Access Compliance Report

Public Rights-of-Way

Intersection ID: 15316	Main Street: CARLING_AV	Cross Street: CHARLOTTE_DR	Location: W
ADA ID: D6C13DEFD228	Ramp Type: Perp	Initial Pass/Fail: Fail	Overall Compliance: No
		Severity Score: 25

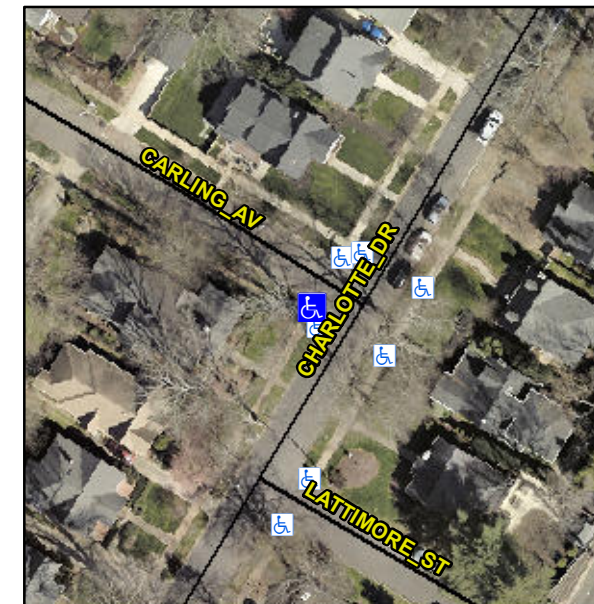
Not Found, R304.5.3

Compliance	Description	Data	Compliance	Description	Data
N/A	Ramp Length (in)	68.0	Yes	Ramp Slope (%)	7.4
Yes	Ramp Width (in)	48.0	No	Ramp XSlope (%)	8.6
N/A	Flare Type LT	N/A	N/A	Flare Type RT	N/A
N/A	Flare Slope LT (%)	N/A	N/A	Flare Slope RT (%)	N/A
N/A	Flare Traversable LT?	N/A	N/A	Flare Traversable RT?	N/A
N/A	Landing Length (in)	N/A	N/A	DWS Provided?	N/A
N/A	Landing Width (in)	N/A	N/A	DWS Contrast?	N/A
N/A	Landing Slope (%)	N/A	N/A	DWS Length (in)	N/A
N/A	Landing X Slope (%)	N/A	N/A	DWS Full Width?	N/A
N/A	Landing Curb? (Y/N)	N/A	N/A	DWS Offset (in)	N/A
N/A	Shared Landing?	N/A			
N/A	Gutter Ponding?	N/A	N/A	Gutter Slope (%)	N/A
N/A	Gutter Lip Ht (in)	1.0	N/A	Gutter X Slope (%)	N/A
N/A	Painted X Walk1?	No	N/A	Painted X Walk2?	N/A
	X Walk 1 Direction	To NE		X Walk 2 Direction	N/A
N/A	X Walk 1 Width (in)	N/A	N/A	X Walk 2 Width (in)	N/A
	X Walk 1 Slope (%)	2.7		X Walk 2 Slope (%)	N/A
	X Walk 1 X Slope (%)	2.6		X Walk 2 X Slope (%)	N/A

Remove & Replace Entire Ramp.
